# SPECIAL PROVISION

## Signal and Light Supports

C-R-S: ROS-159-0.41

PID: 113013

EST. WEIGHT:	DRAWING NO.:
3951.3	213267-1

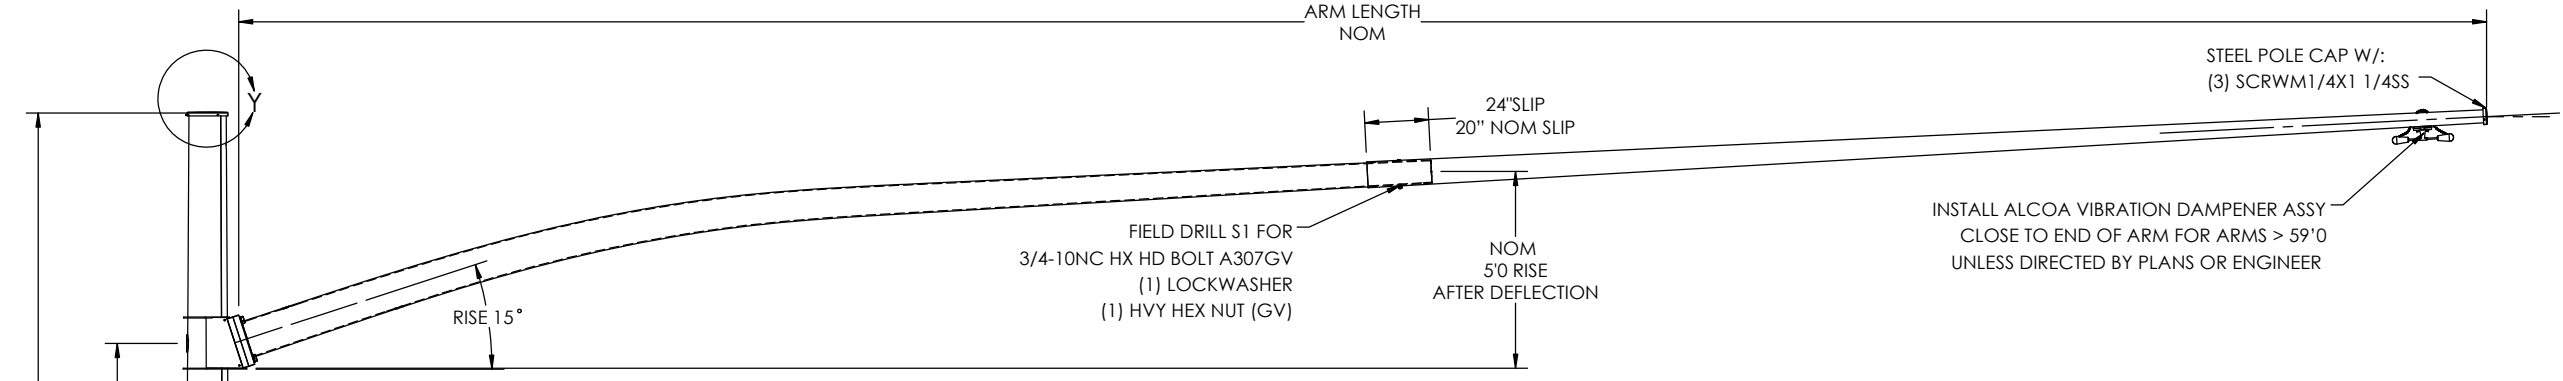
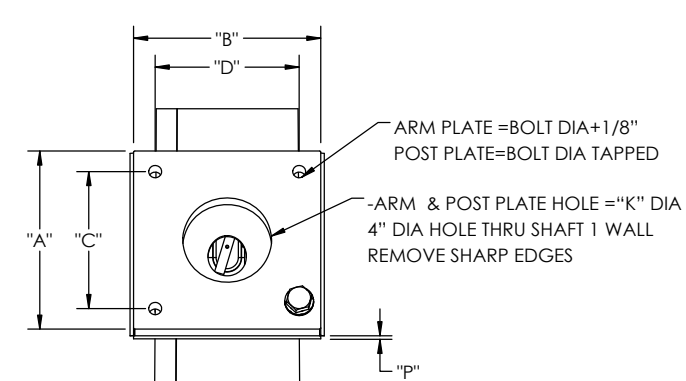
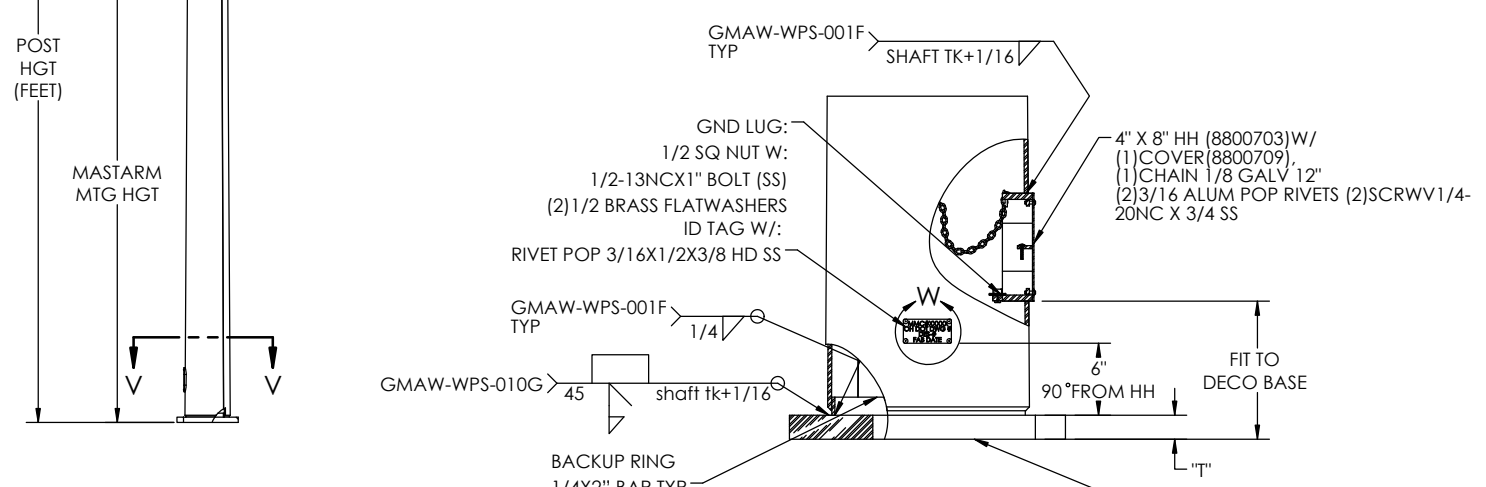
REVISIONS				
REV.	ECO	DESCRIPTION	DATE	DRFT
A		REVISED POLE HEIGHTS, MAST ARM MTG HEIGHTS, LUM & COUPLING DETAILS TO MATCH CUSTOMER COMMENTS. REVISED STD SIZES FOR BASE PLATE CONNECTION AND ALCOA LOCATION TO MATCH ODOT	10/4/2024	RK

CATALOGUE NO.: KSB10  
 QUANTITY:  
 MATERIAL: ALUMINUM  
 PAINT: SMOOTH FEDERAL STANDARD #17038 (STOCK CODE #PWDC11014-1)

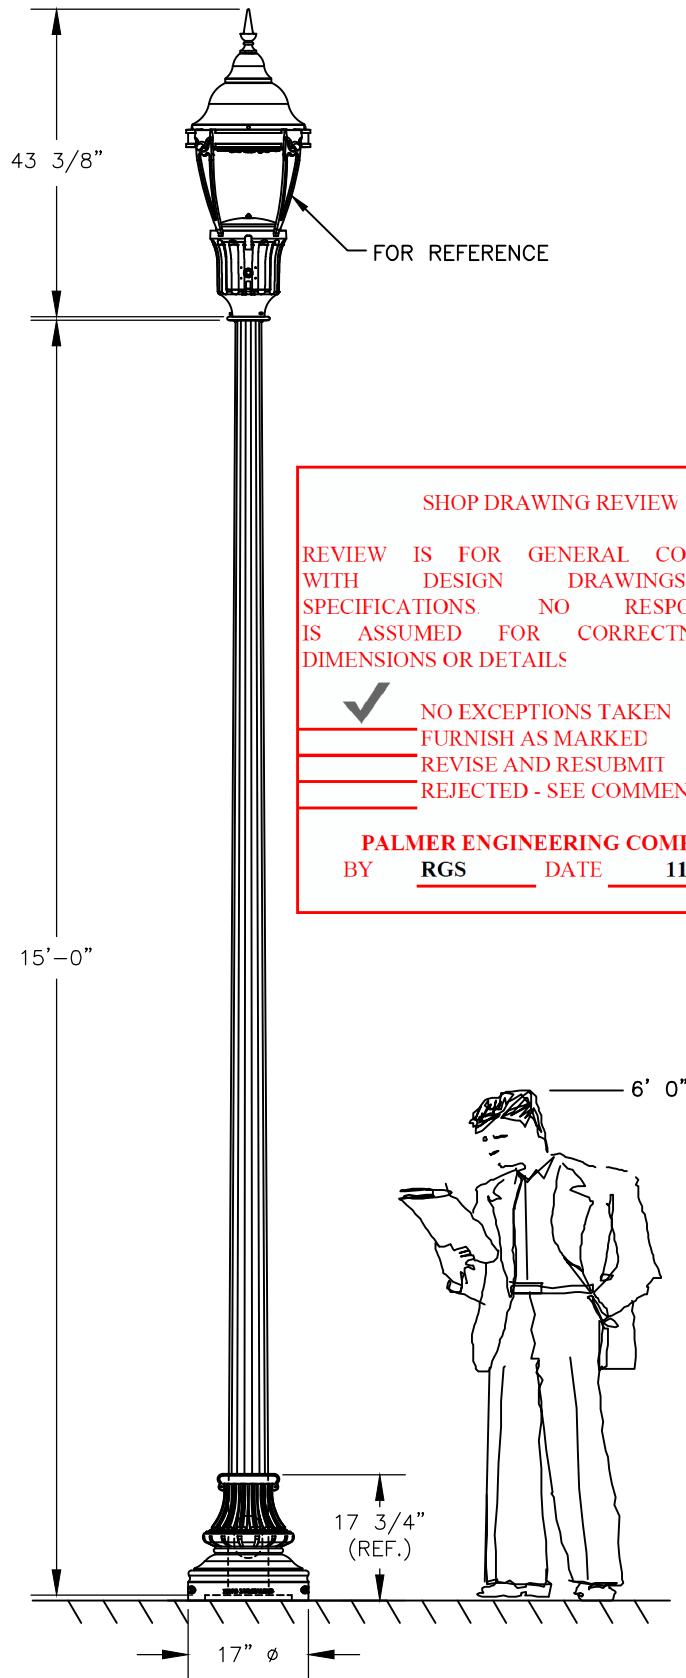
REV.	ALTERATION	DATE	BY
A	SPLIT BASE WAS KSB16	08/26/24	JH
B	UPDATED PER CUSTOMER COMMENTS	11/08/24	JH
